SEWAGE DISPOSAL SYSTEM

MARYLAND STATE DEPARTMENT OF HEALTH

SUBDIVISION Warfield Estates ROAD 3326 Stapleton Drive LOT 38

PROPERTY OWNER Kevin Perdue

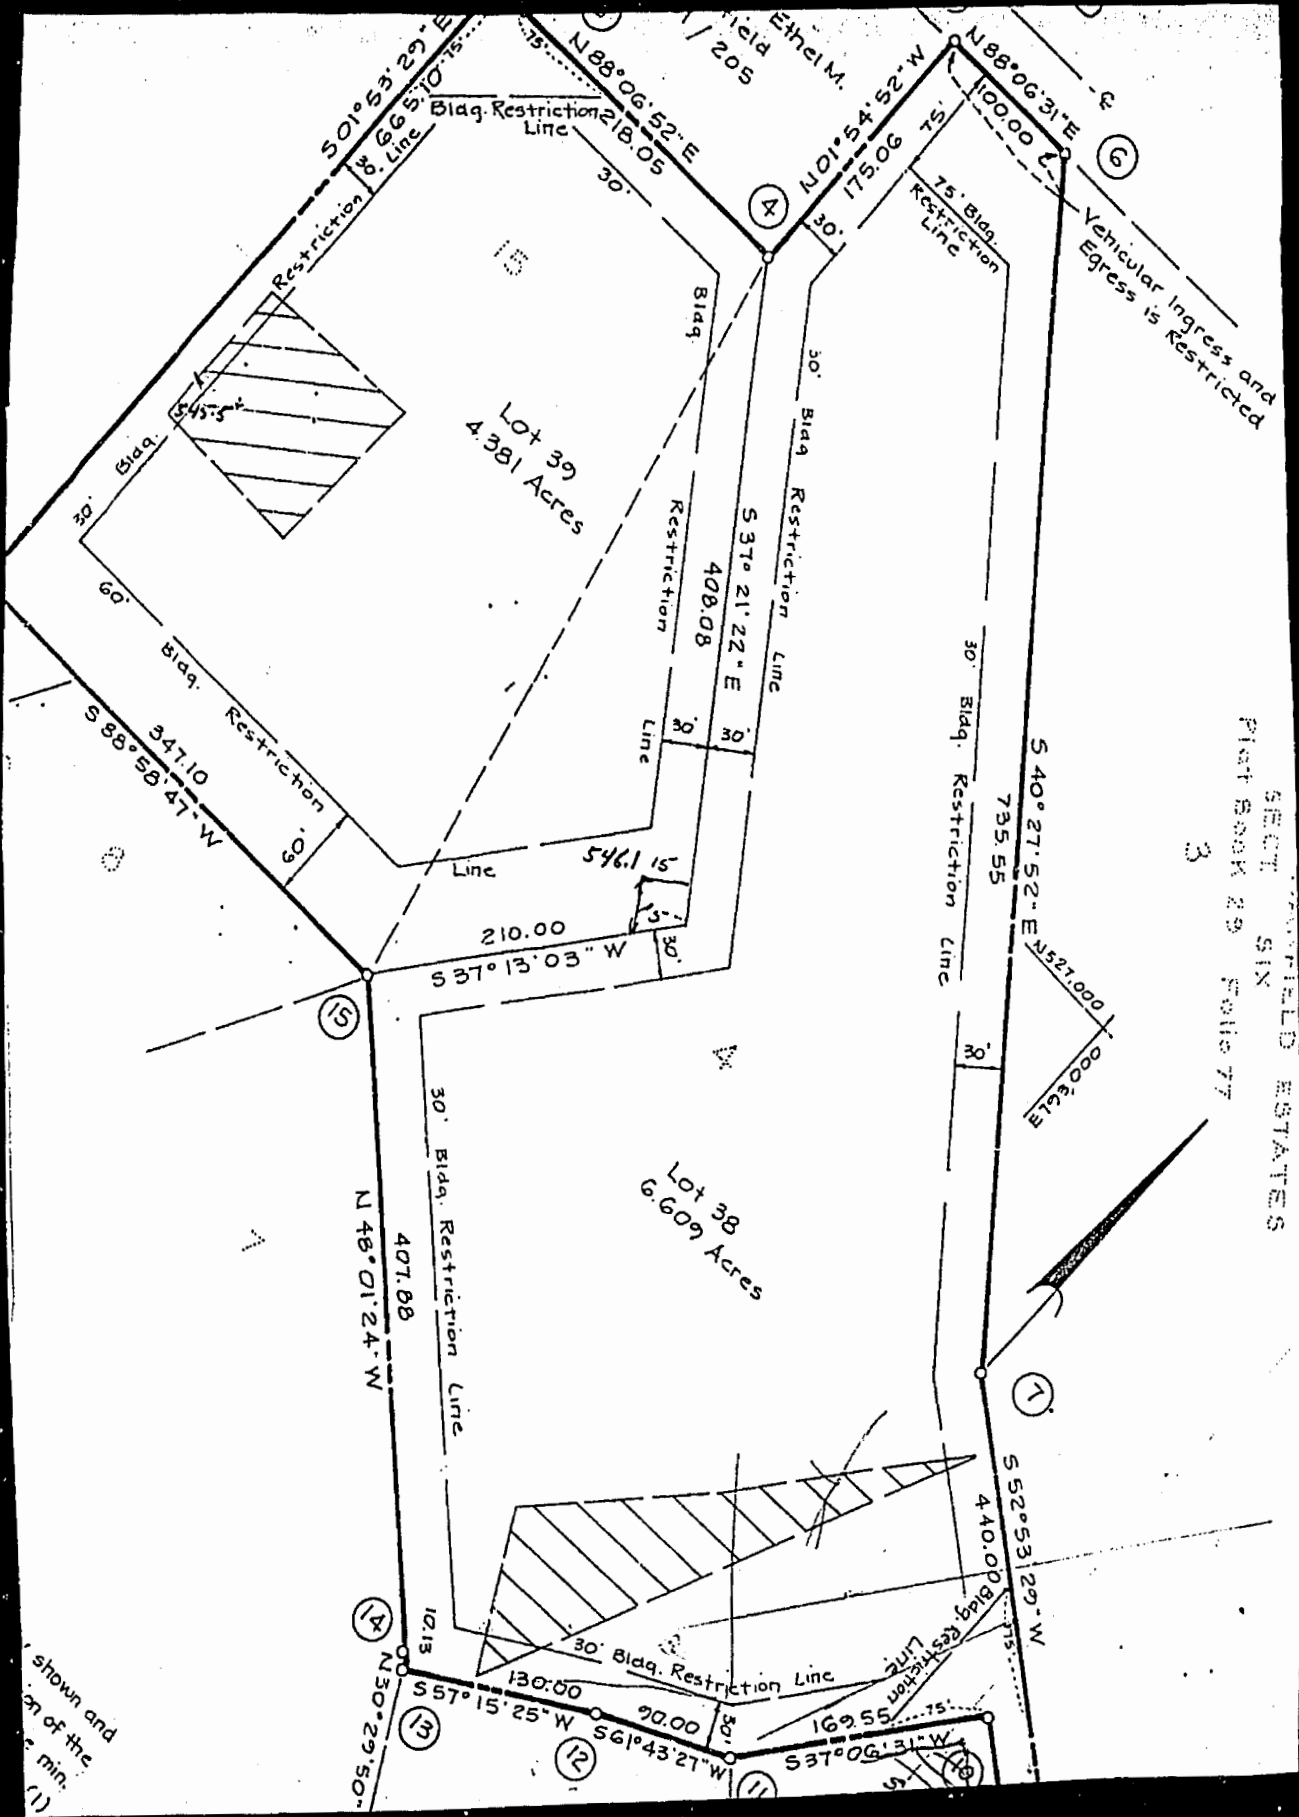
REMARKS 11/5/87 System 1st. Agreed to location for D.B. & trenches compatible with well location & relative septic location. Box & trenches to be installed 1st & work back from there to get proper fall & septic tank location.

1/5/87 OK to add stone pipe & paper to trench 1st (circled)

1/6/87 OK TO WORK. ALL WORK, NEED HOUSE REMOVED BEFORE FINISH. S. KRAL

3/12/87 House connection verified (circled)

10296

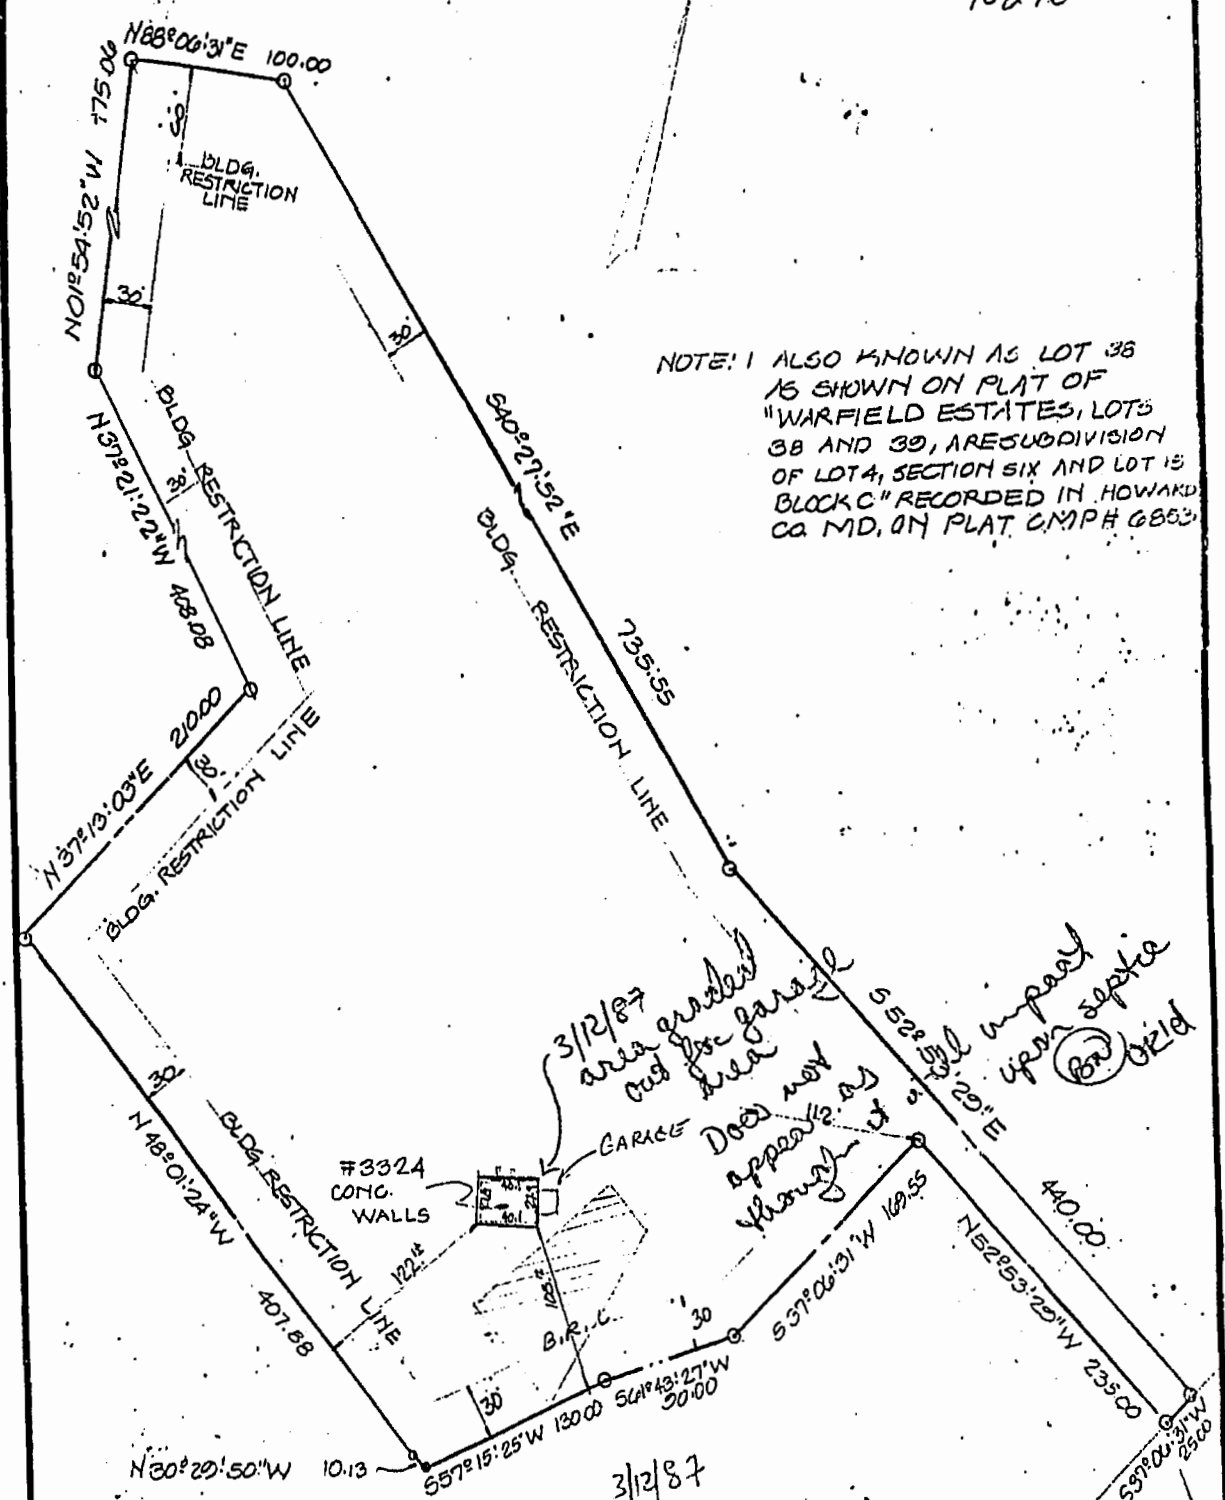
3/12/87
 area graded
 out for garage
 Does not
 appear to be
 through it
 5' x 12' impact
 upon septic
 field

3/12/87
 (when garage is
 sealed in, would
 be ≈ 10' (at best)
 from septic field)
